HOLDEN COMMODORE VE SERIES I 6L V8 AIR CONDITIONER BELT KEEPS COMING OFF

HOLDEN COMMODORE VE SERIES I 6L V8

VE Commodore Series 1
(Tensioner only on A/C)

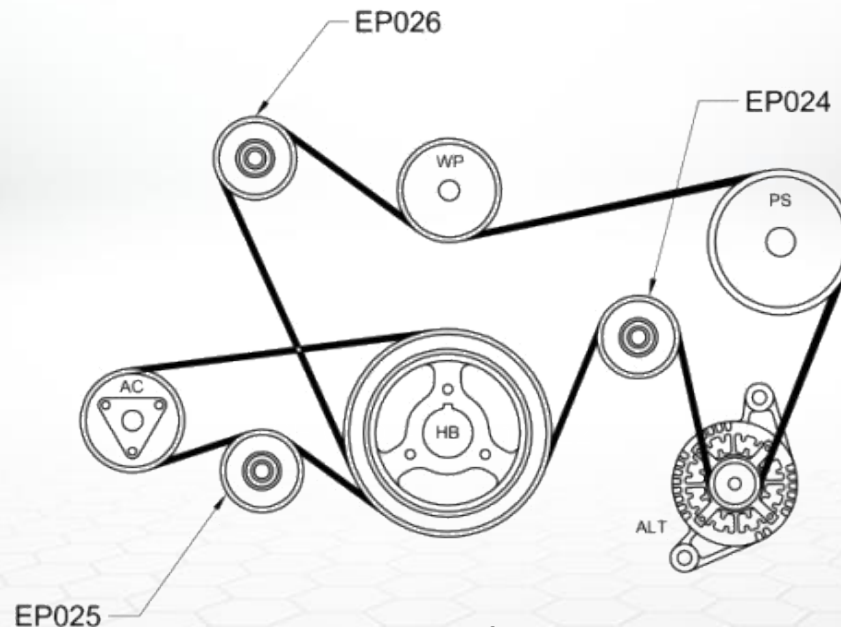
When under load the A/C will throw off and
in some cases destroy the belt
